**STAFF REPORT**  
**COMMUNITY DEVELOPMENT DEPARTMENT**

HEARING DATE: 10/15/2020  
 TO: Planning & Zoning Commission  
 FROM: Sonya Allen, Associate Planner  
 208-884-5533  
 SUBJECT: H-2020-0079  
 Skybreak  
 LOCATION: 7020 S. Eagle Rd. & 3487 E. Adler Hof Ln., in the south 1/2 of the NW 1/4 of Section 4, T.2N., R.1E. (Parcels # S1404244250 & S1404233650)

B. Preliminary Plat (date: 6/15/2020) & Phasing Plan

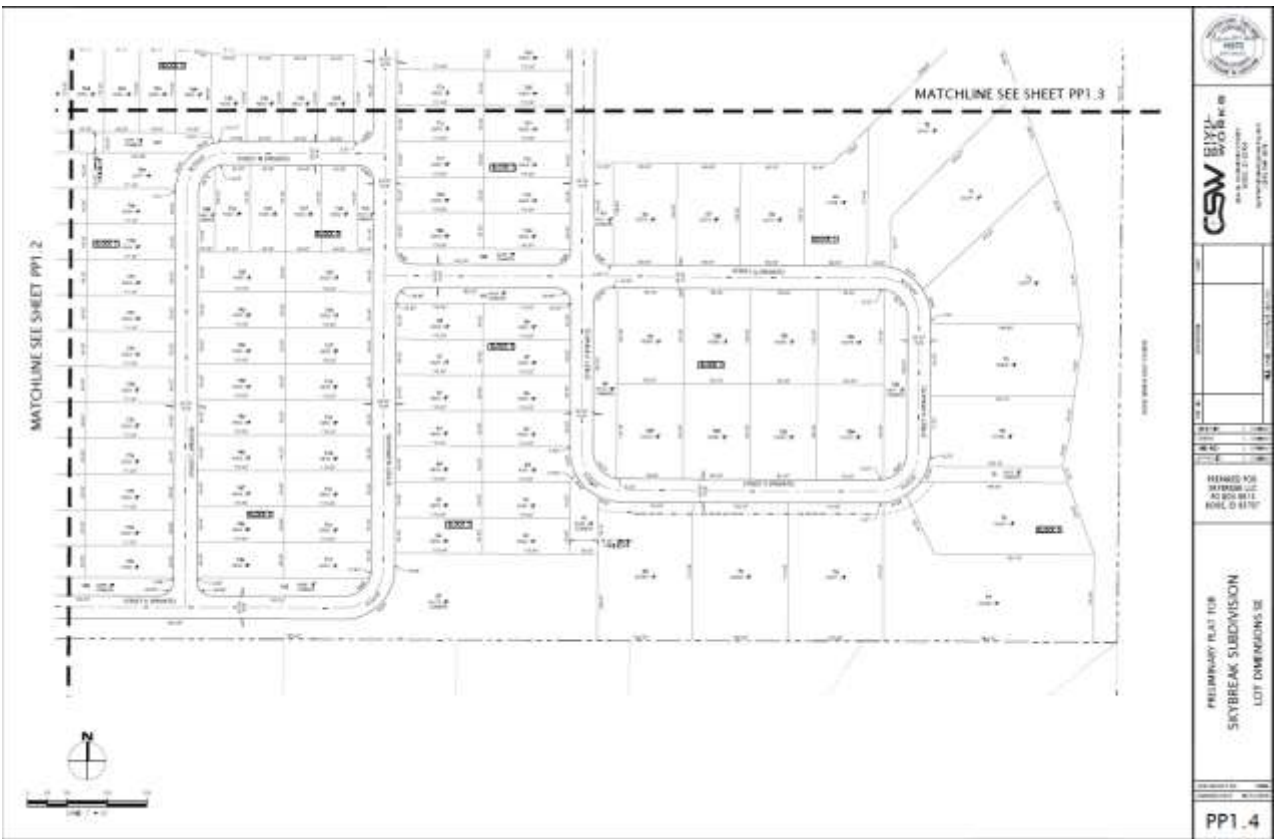
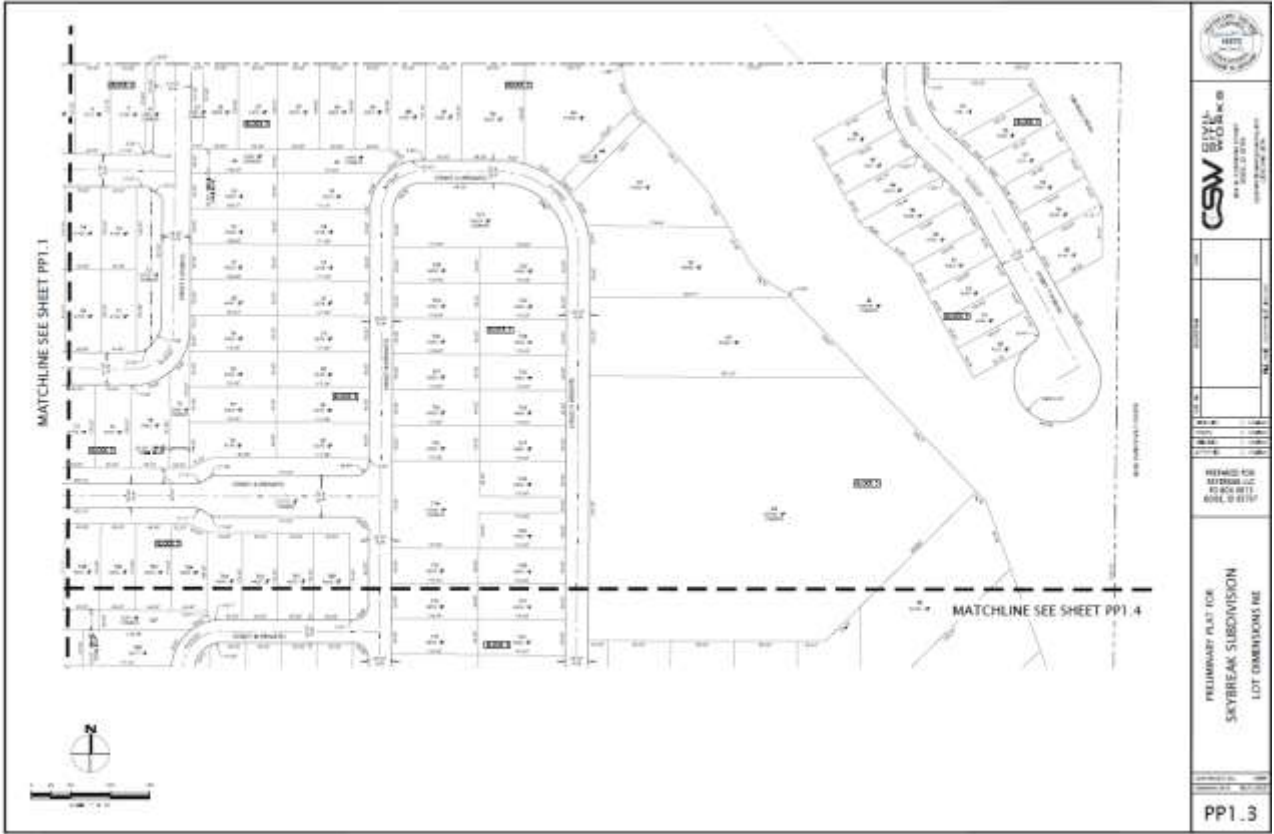
Development is subject to the dimensional standards listed in 11-2A-6 for the R-8 zoning district. **Several of the lots don't meet the minimum street frontage requirement of 40 feet.**

**Although the proposed access meets the minimum access required by the Fire Dept., Staff is *highly* concerned with the feasibility of only one (1) public access to the site (until adjacent properties redevelop and provide stub streets to this property) with 353 units proposed. Additionally, if access from the north via Eagle Rd. is blocked, in the event of an emergency, emergency vehicles would have to travel an additional 3.5+/- miles around the square mile to access the site creating a potential life safety issue due to a delayed response time.**

Existing Home to remain (above)

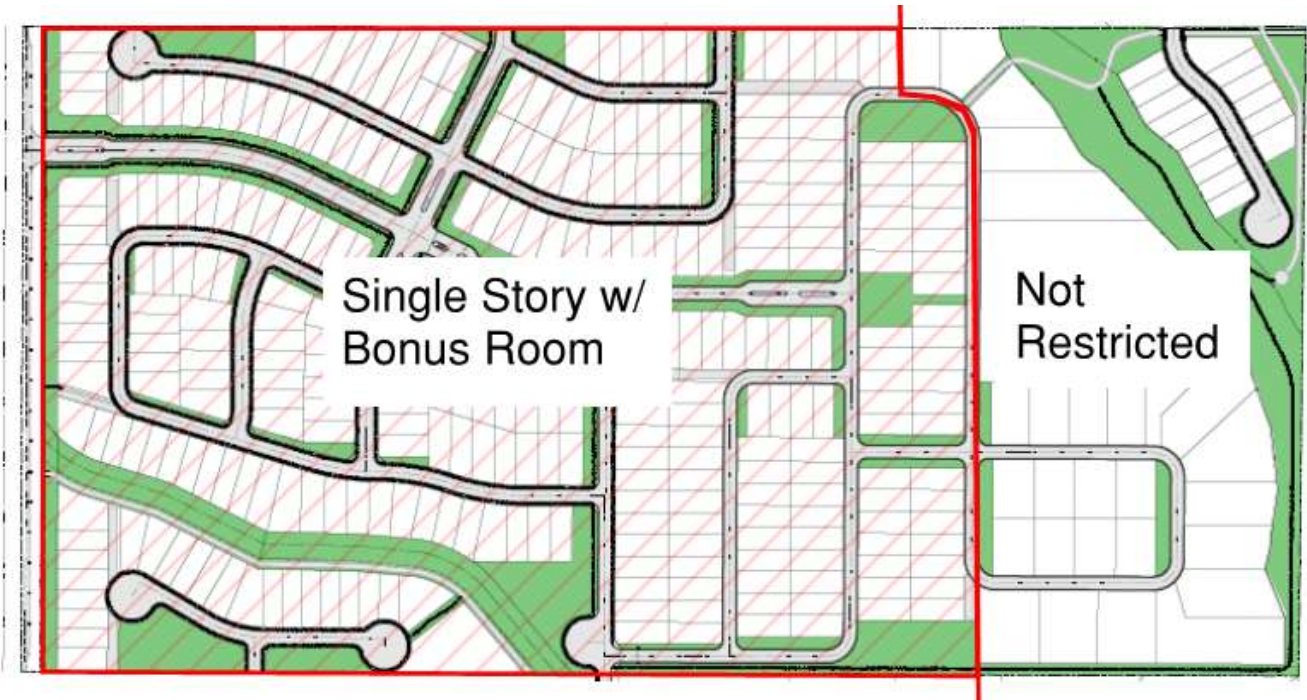
**NOT APPROVED**
